Interior Load Bearing Wall- Family Room

**These photographs are directly related to the same section of this report
as identified above.**

2103 Compromised Wall Electric

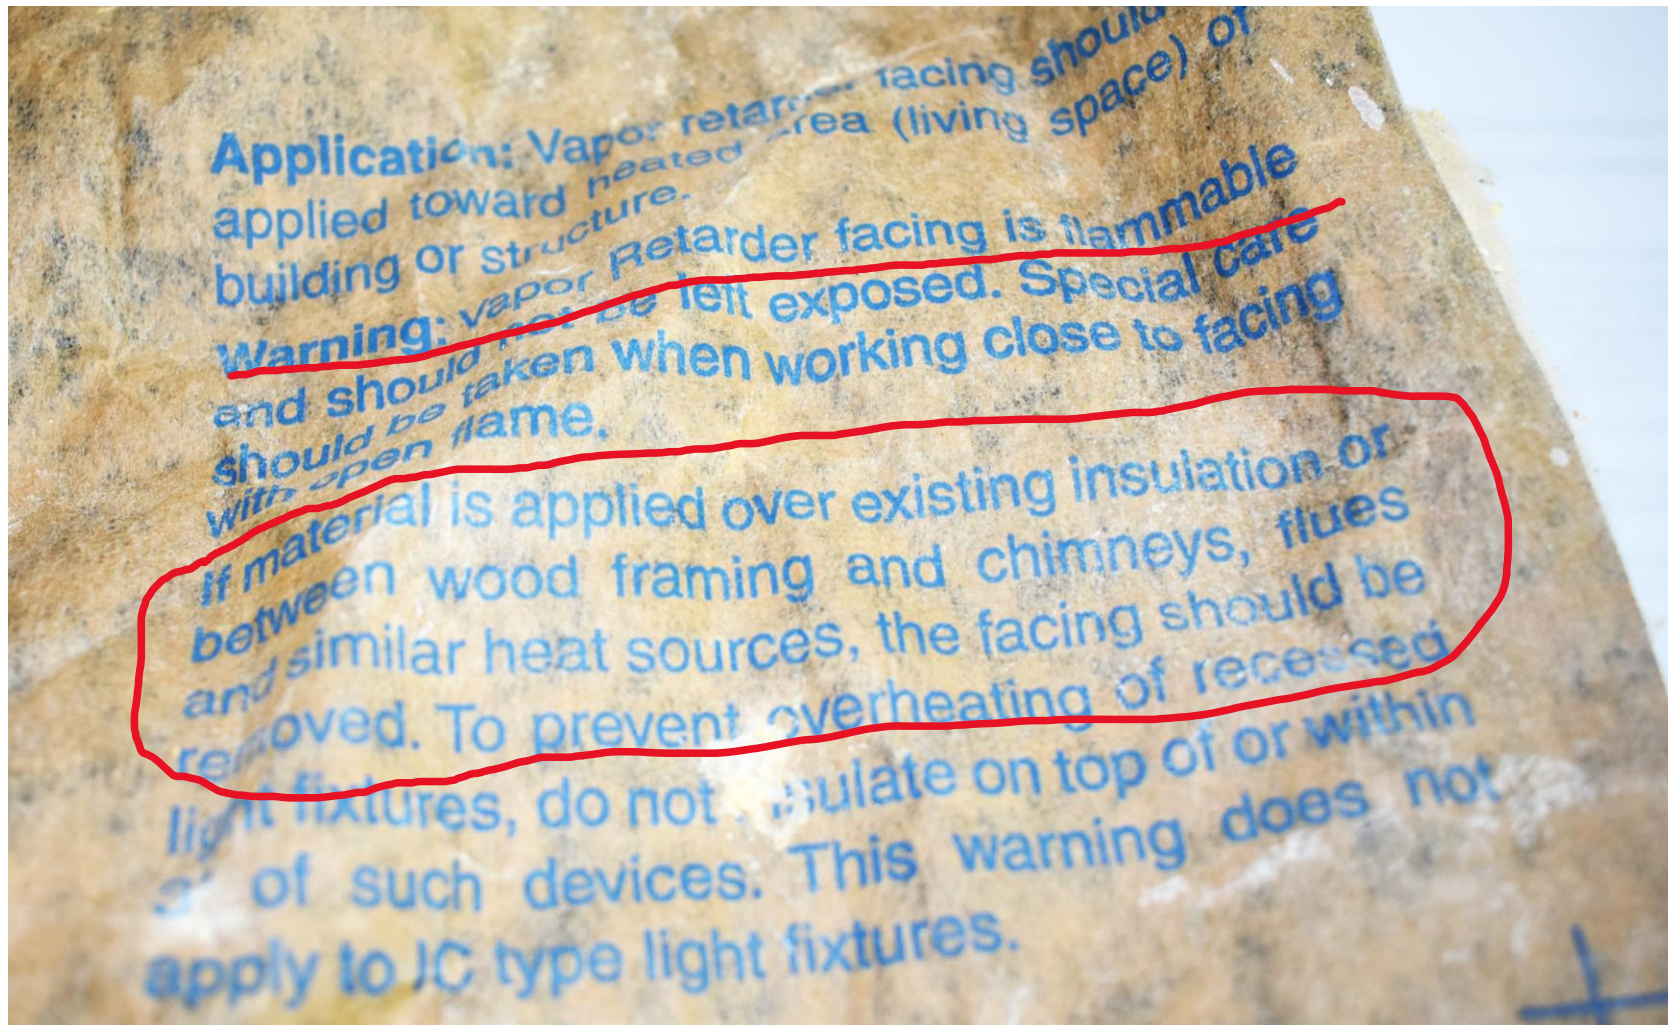
The wire in the middle of the picture was directly terminated to the fireplace and not to a junction box per code.
